MEMORANDUM

Date: September 7, 2016

Subject: **Willard's C-Store**

I've completed a review of the above mentioned Site Plan and Drainage Report and have the following comments:

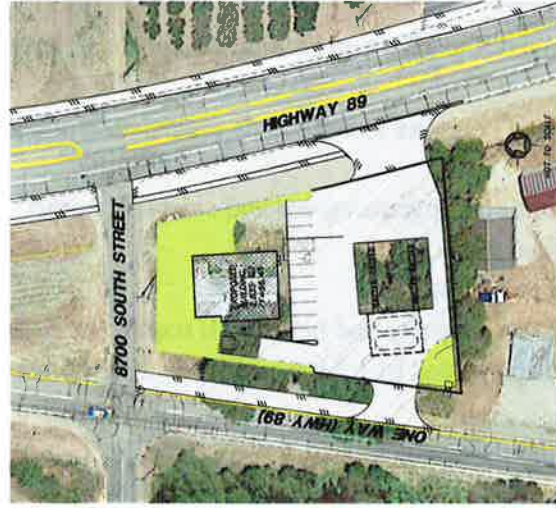
Plans need to be signed and sealed

UTILITY PLAN

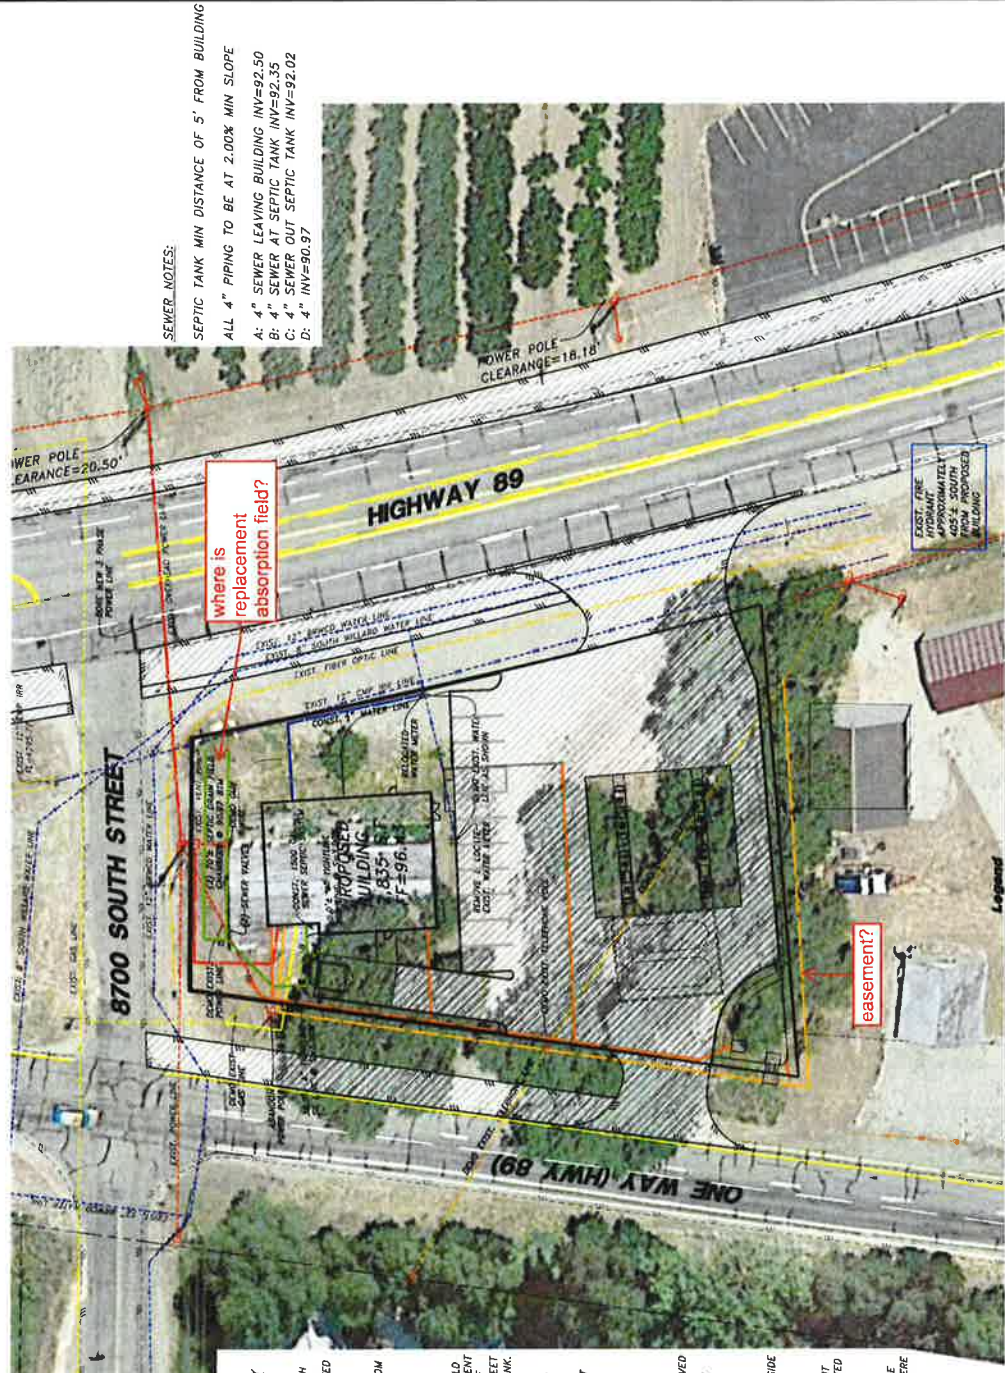
where is replacement absorption field?

easement?
